ADDENDUM TO THE CONTRACT

Auke Bay Elementary School Renovation

Contract No. E12-042

ADDENDUM NO.: TWO

L502

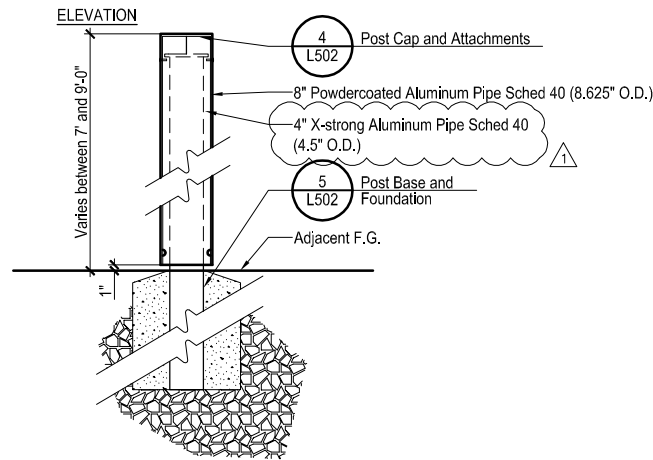
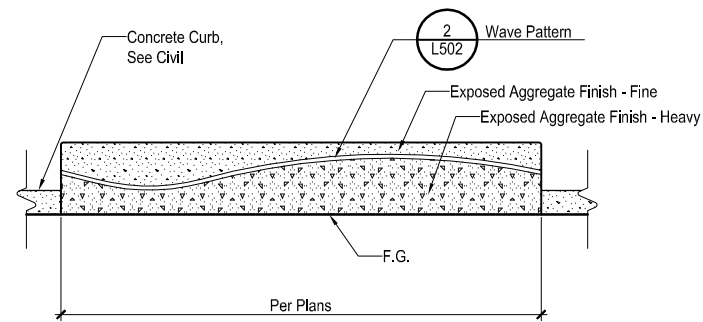
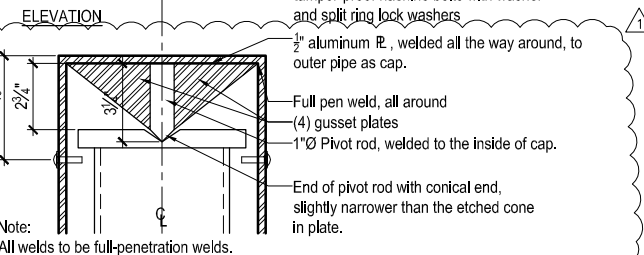
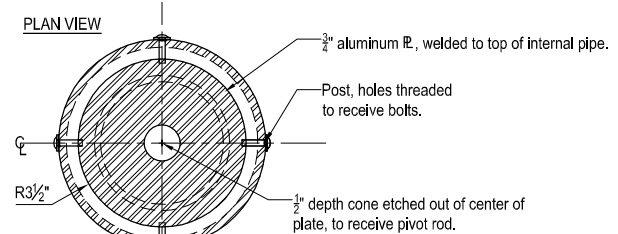
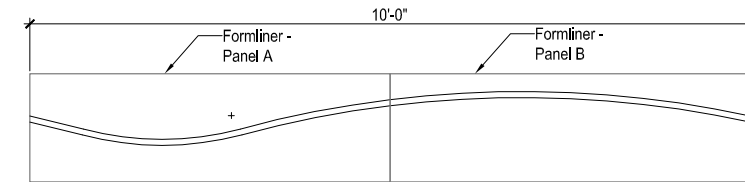
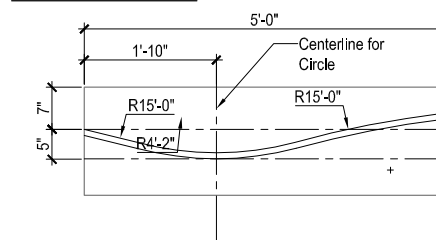
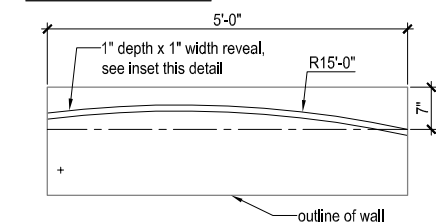
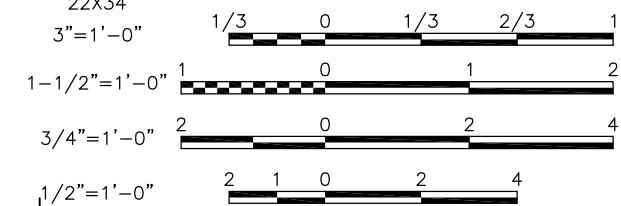
43. Sheet L502: **Replace** with the attached Sheet L502 labeled Addendum No. 2.
44. Sheet C400: Sheet C400 titled “Typical Sections” under Typical Section Notes **Add** “8. Additional excavation is required for the geothermal loopfield work; see mechanical sheets M400 and M704 for locations and details.”

S505

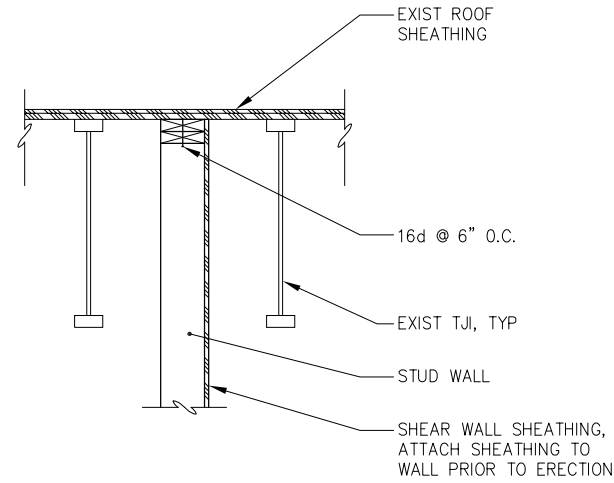
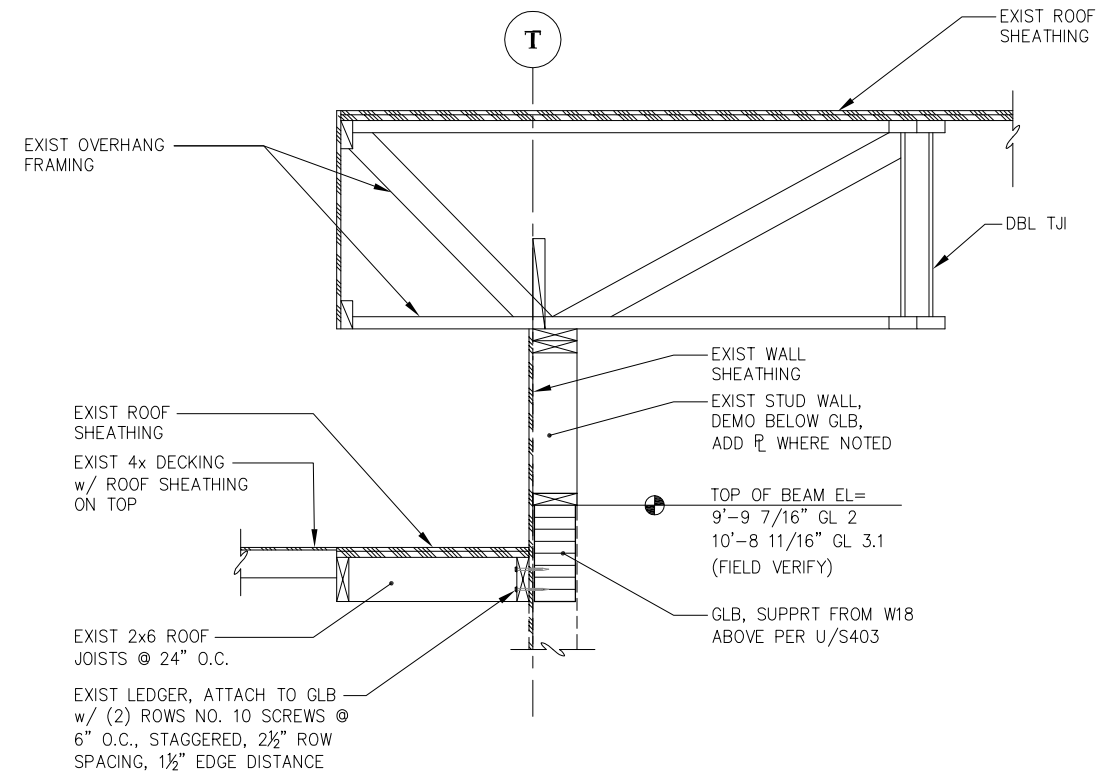
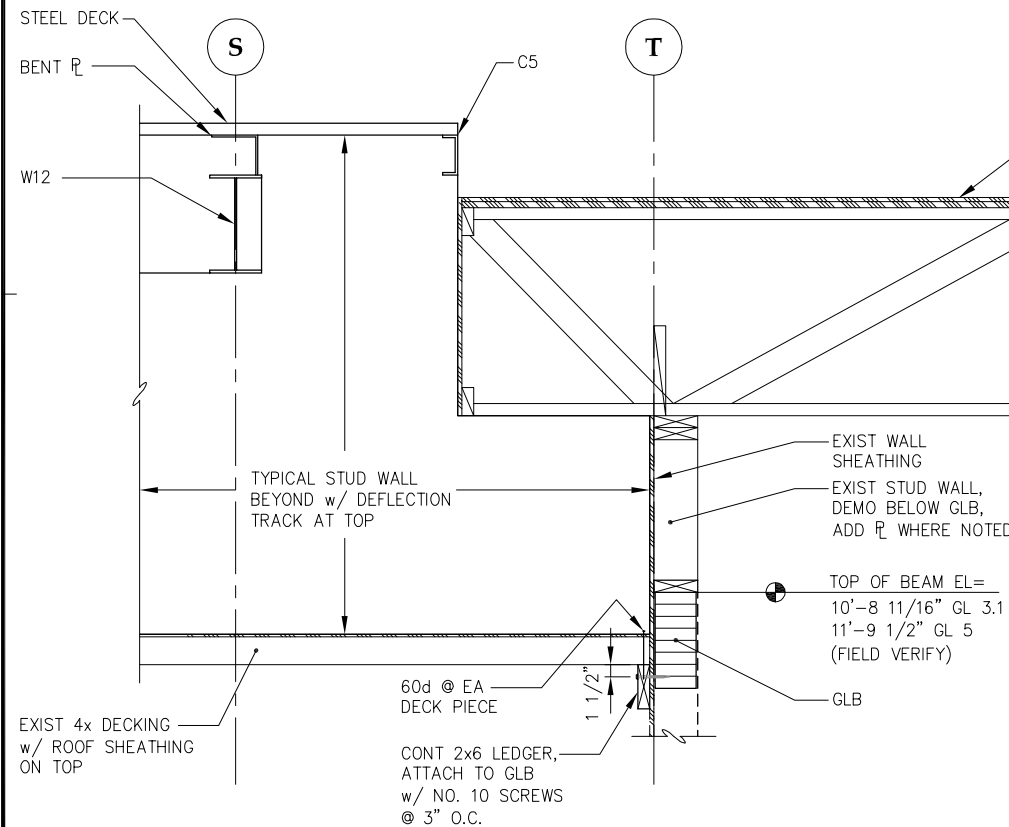
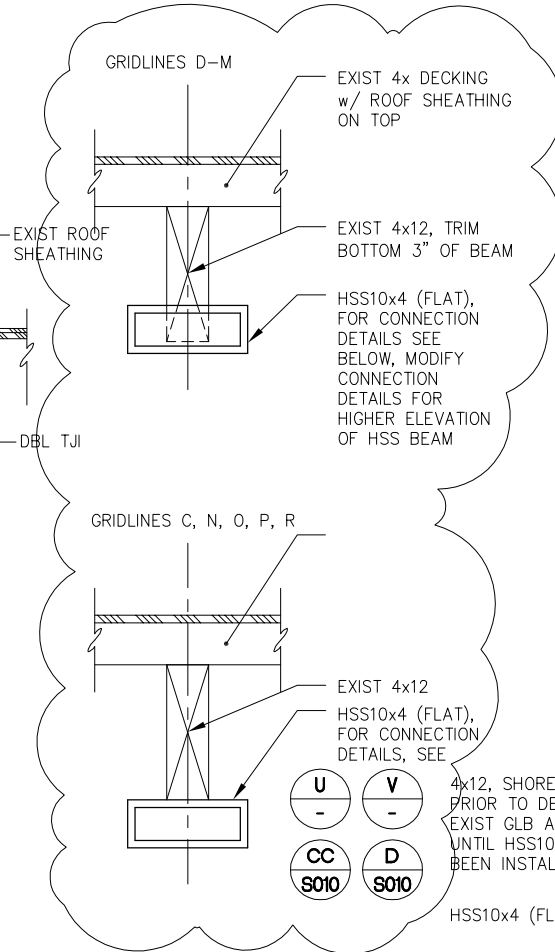
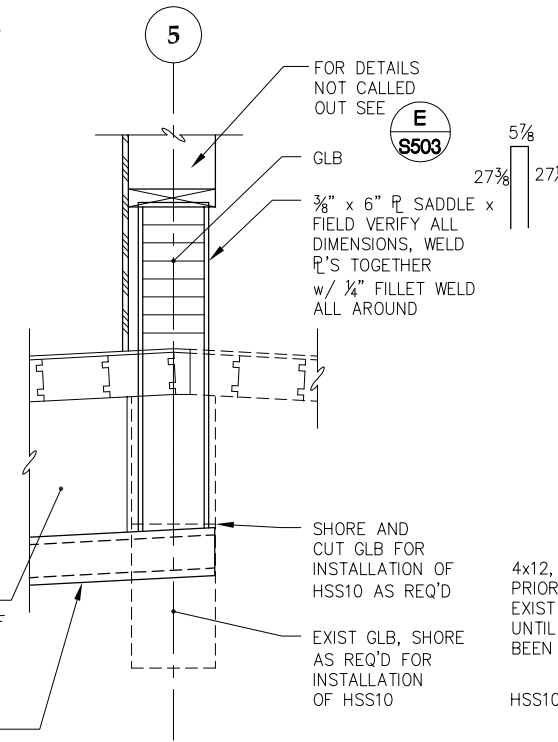
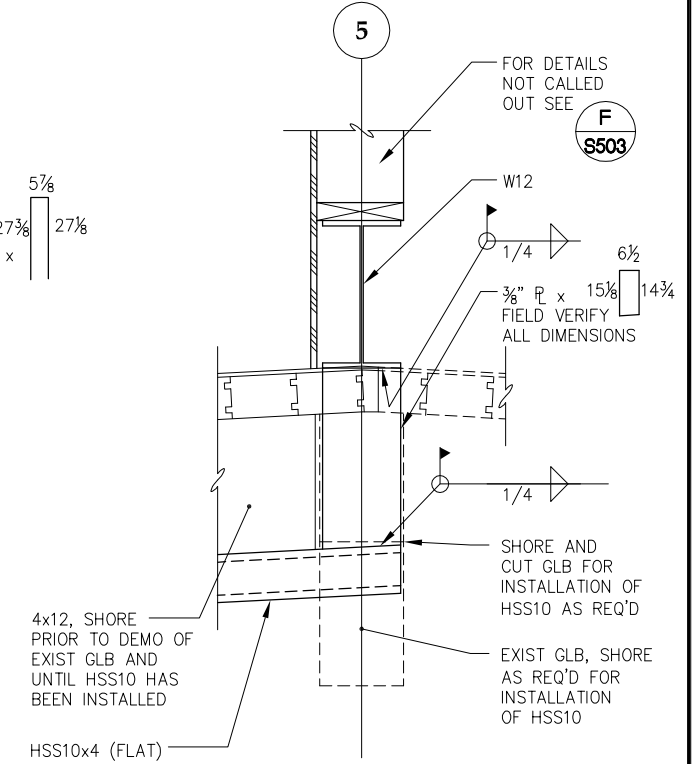
45. M002 **Revise** EF-2 and EF-3 electrical to 208 volt, 3 phase.
46. S505 **Replace** with the attached Sheet S505 labeled Addendum No. 2
47. M003 **Add** automatic valve and flowsetter G12 to the Automatic Valve and Flowsetter Schedule on sheet M003. G12 shall serve minimum flow for Pumps P-1A and P-1B and shall be located in Mechanical 122. Flow rate: 60 gpm. Flowsetter size: 2-1/2 inch. Pipe size: 2-1/2 inch. Pressure drop: 5 psi. Modulating 2-way DDC automatic valve.

M404

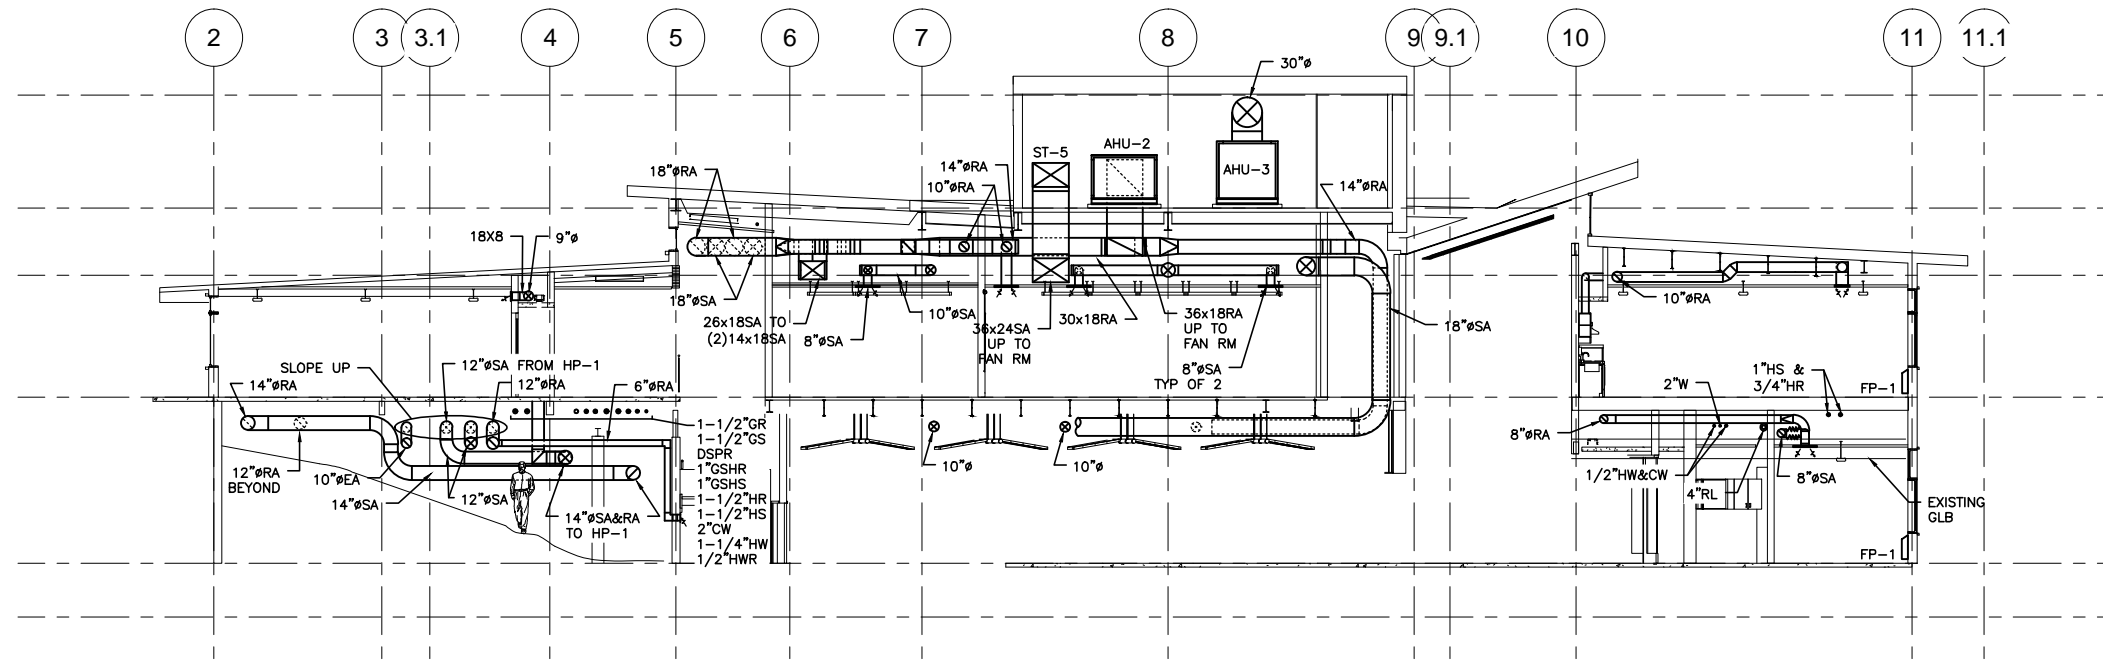
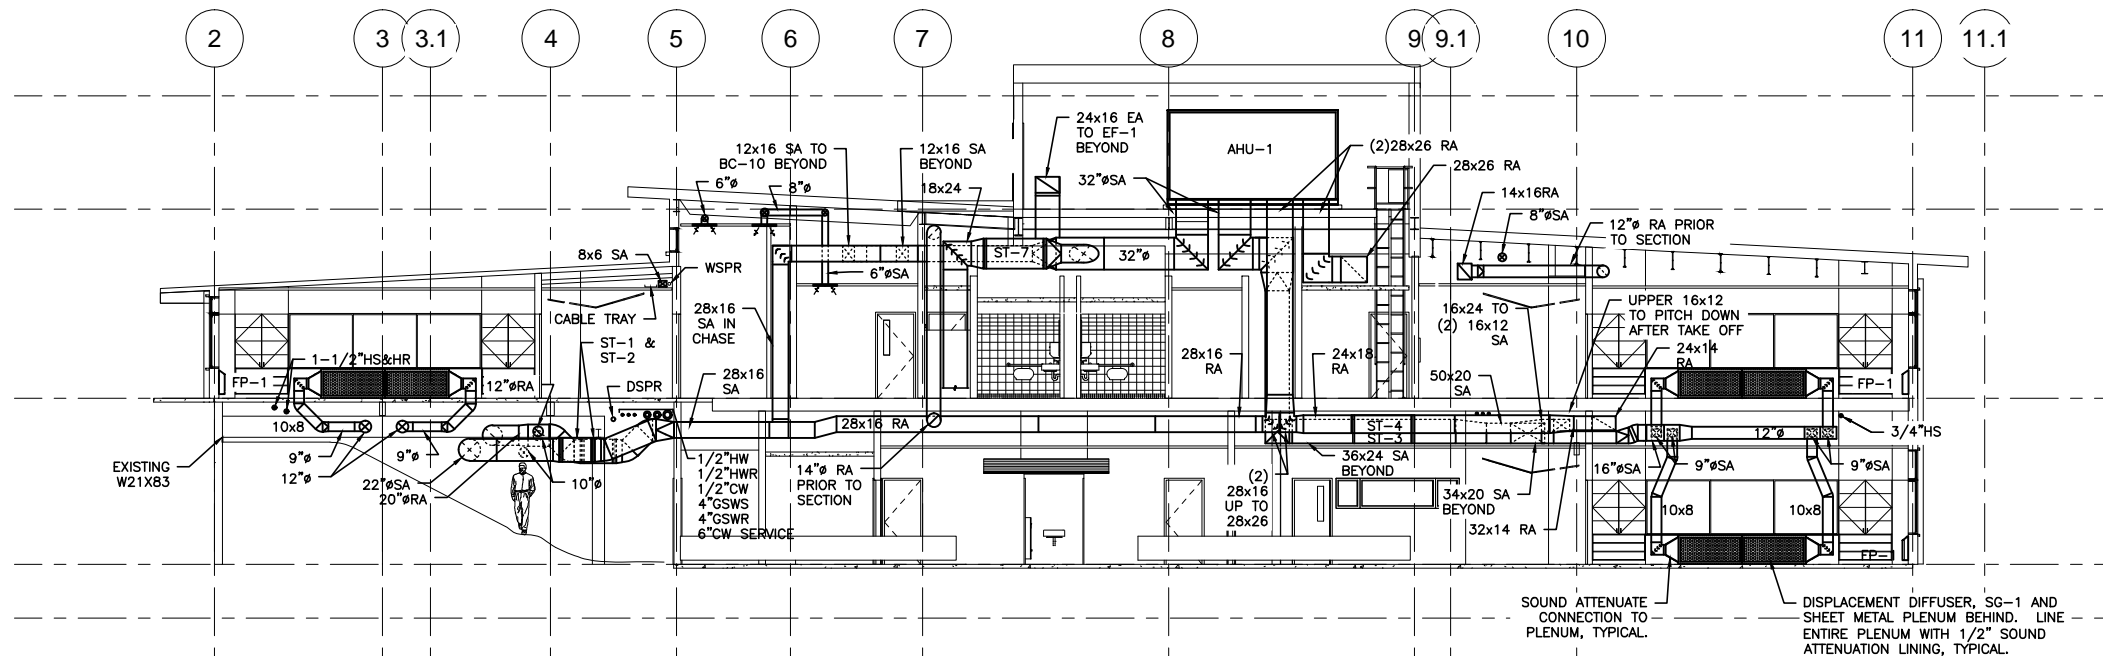
56. M404 **Replace** entire M404 Drawing with attached M404.
57. Sheet E001: **Change** text for data outlet to read, “Data, 18” AFF UON. One jack per outlet UON in plan.”

E201

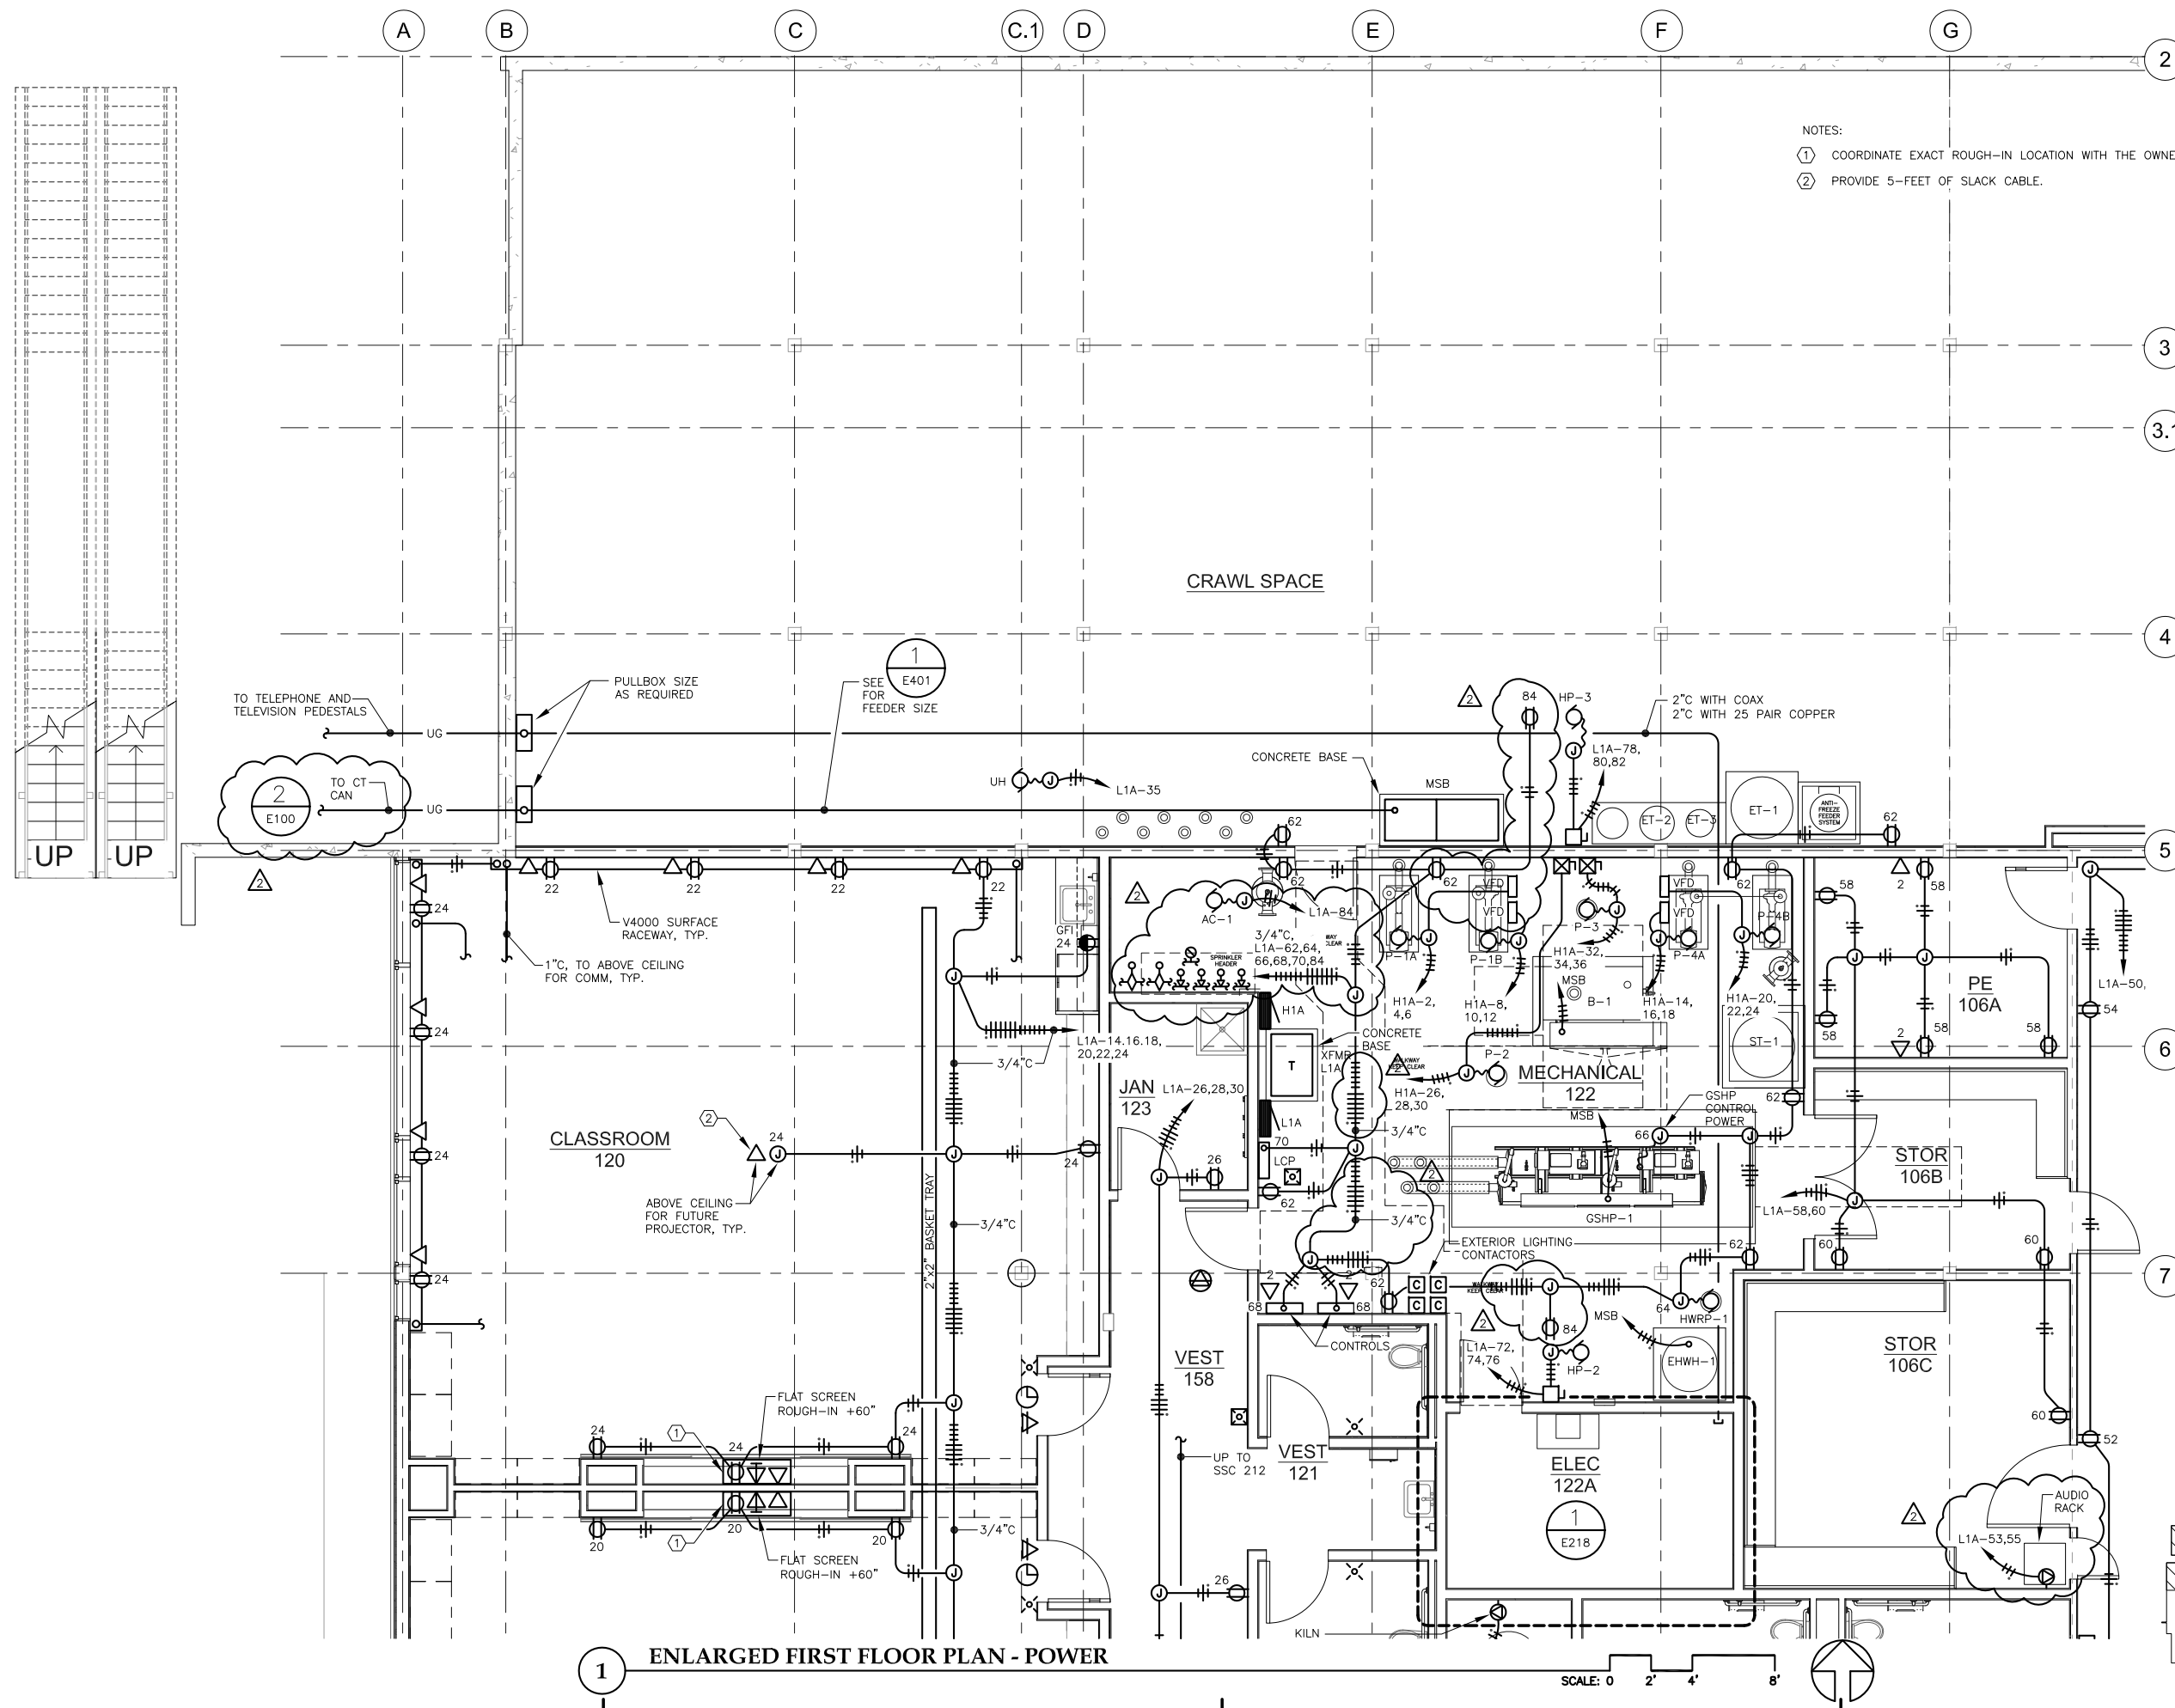
58. Sheet E101 Detail 1: **Change** detail call out at canopy photocell to read 2/E402.
59. Sheet E201 Detail 1: **Replace** sheet with attached re-issued sheet.
